**NOTICE OF A REGULAR MEETING
BONDURANT PLANNING AND ZONING COMMISSION
OCTOBER 7, 2025**

TITLE: Resolution PZ-251007-31 - Consideration of Bondurant-Farrar Community School District Elementary Site Plan.

PROJECT NO:
24098
DATE:
08-21-2025
SHEET SET:
50% CONSTRUCTION
DOCUMENTS
SHEET NAME:
GRADING PLAN

3 WEST ELEVATION
1/16" = 1'-0"

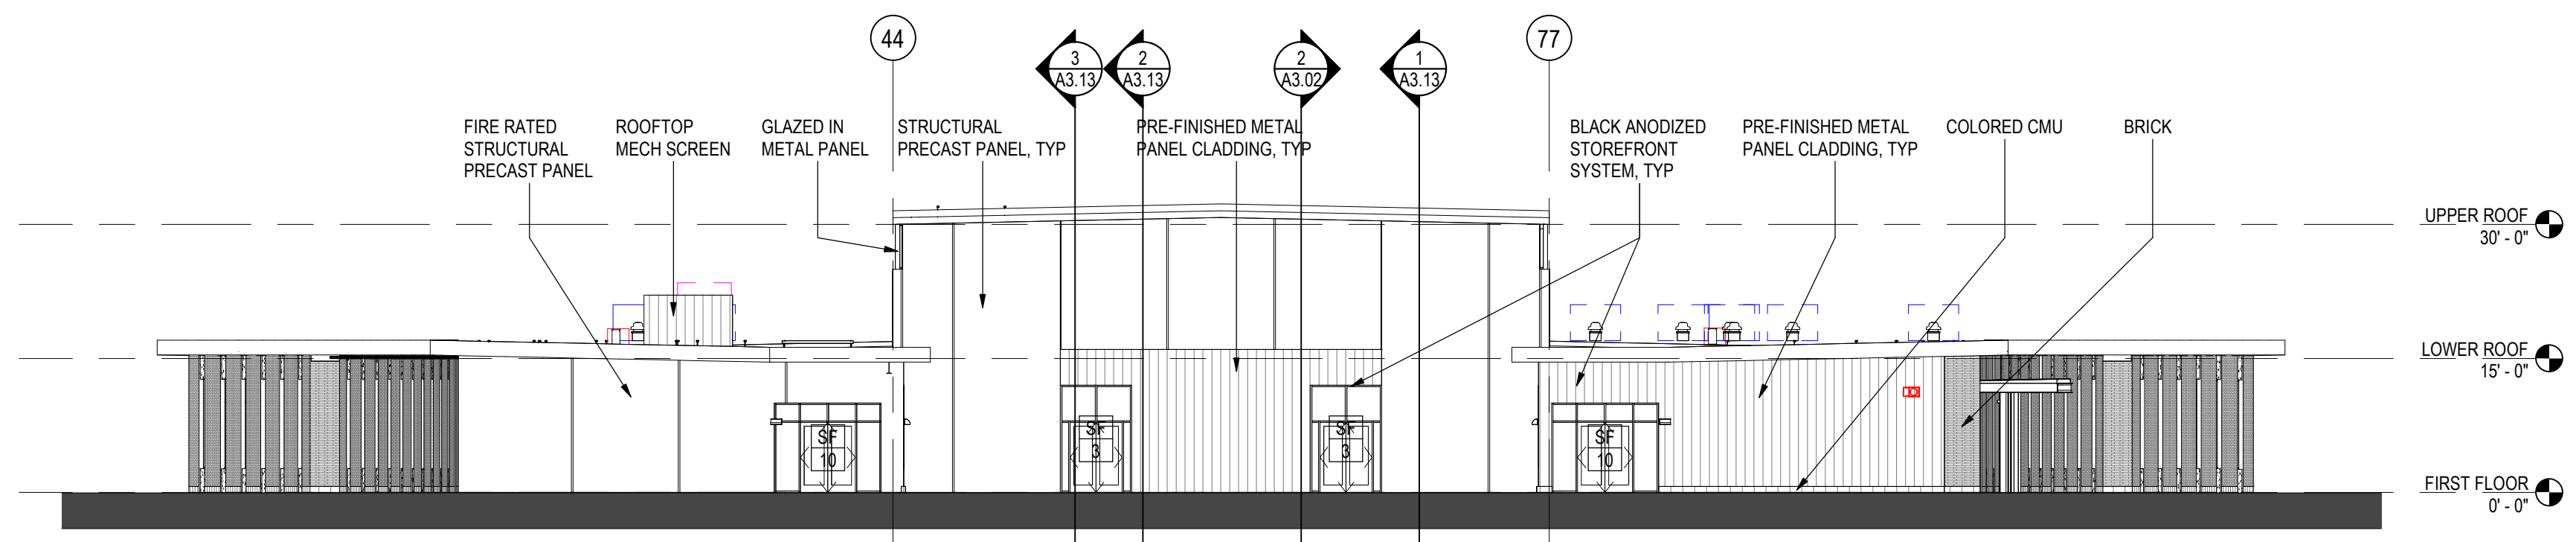
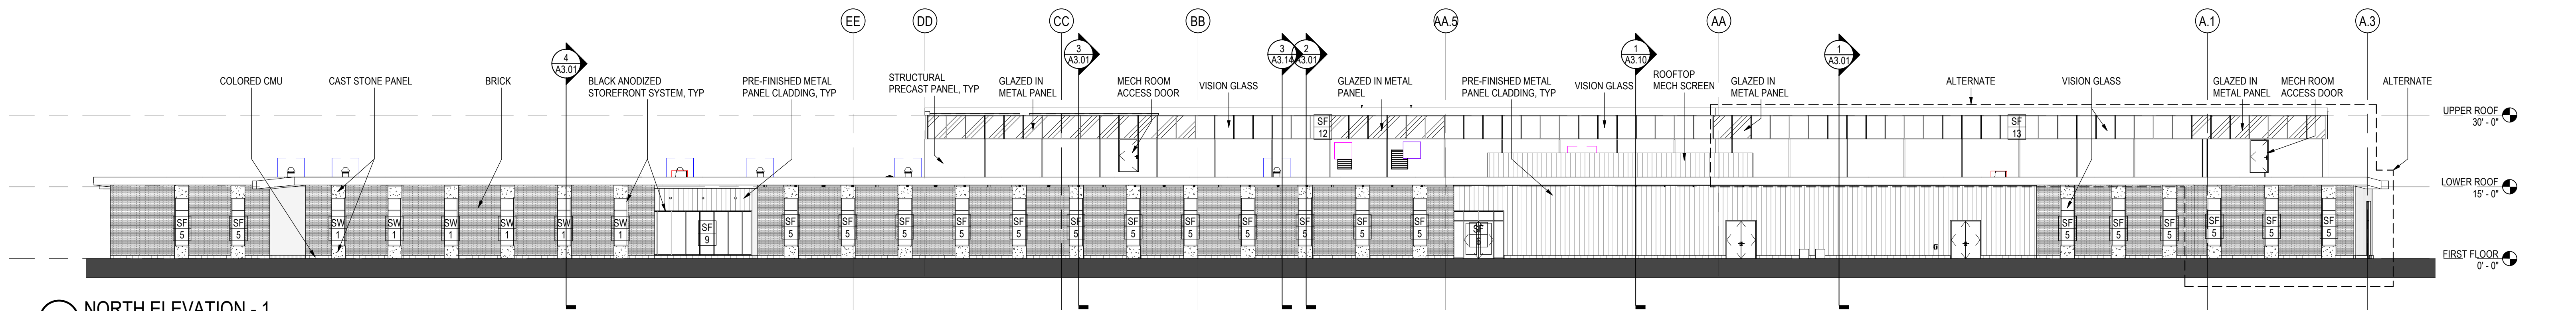
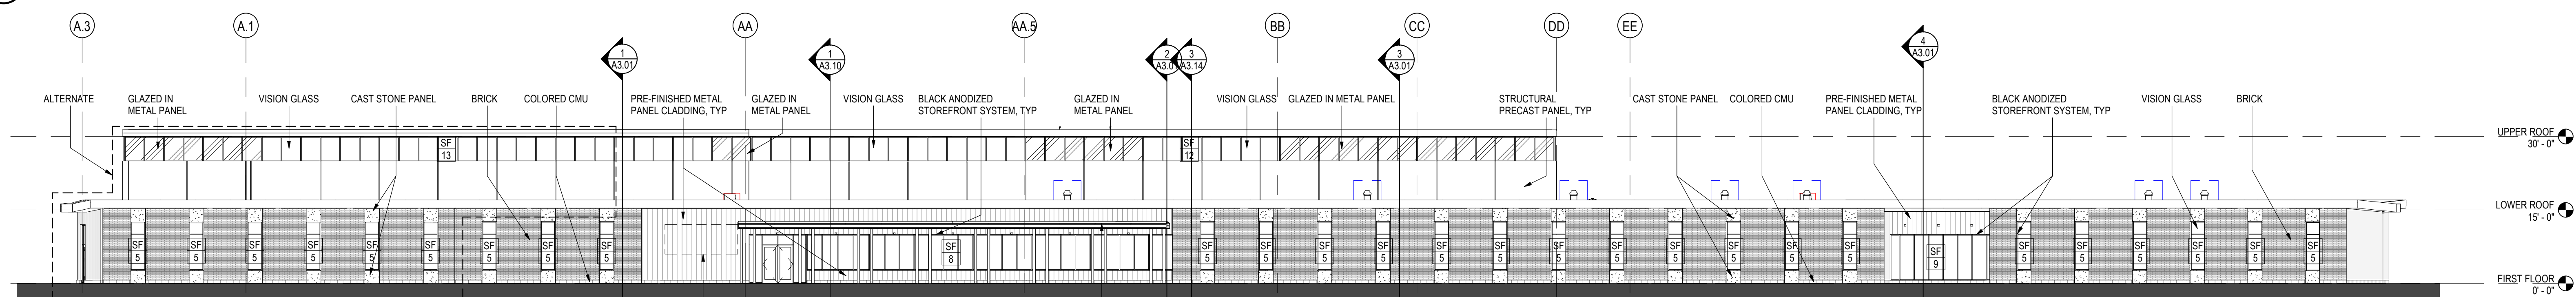
- Architectural elevations have been submitted to staff and appear to meet the architectural design standards. The submitted architectural elevations do not include a percentage breakdown of proposed building materials. The site plan shall be updated to include this breakdown.
